22 January 2020

**Resource Consent Application RM19-0774 – Retrospective Consent for Coastal Reclamation and a Seawall within the Coastal Marine Area – Request for Further Information pursuant to Section 92 of the Resource Management Act 1991 (RMA)**

**Figure 1.** NIWA modelling showing the extent of inundation at the site.

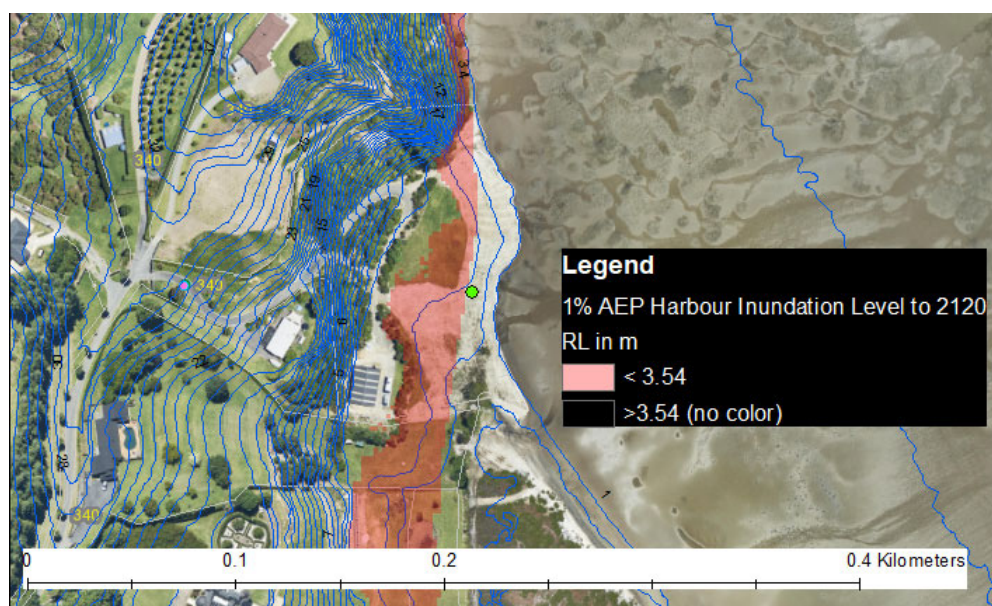
- a) An assessment of effects relating to sea level rise and climate change is required, taking into account the following:
  1. The structure has not been designed to an engineered level. The recommended design level is the 1:100 year inundation level to 2120. This constitutes a 1% annual exceedance probability event (AEP) coupled with a 1.25 metre sea level rise, while taking into account climate change to 2130;
  2. For this site, based on NIWA's latest modelling, inundation will extend to 3.54 metres relative level (RL) as indicated in red on Figure 1 below;
  3. The 1.5 to 1.75m high (FL) wall height will only cater for spring tide elevations, with up to a 0.6 – 0.8m sea level rise, based on NIWA's modelling and would still be overtopped during large storm events. The infill placed behind the structure could for a source of sedimentation to the harbour;

4. The finished design level of the seawall and confirmation of the appropriateness of the design in line with the projected coastal inundation and coastal erosion for the location should be submitted – specifically due to the infill behind the wall and the proximity of the high value area – Natural Character, Indigenous Biodiversity Area A, Tauranga Harbour.

5. A plan of the seawall with surveyed seawall heights should be provided (PVC seawall and additional new seawall).
  6. Dimensions and details of the seawall and reclamation including the portions of the seawall and reclamation within the CMA and the portions of the seawall and reclamation outside the CMA.
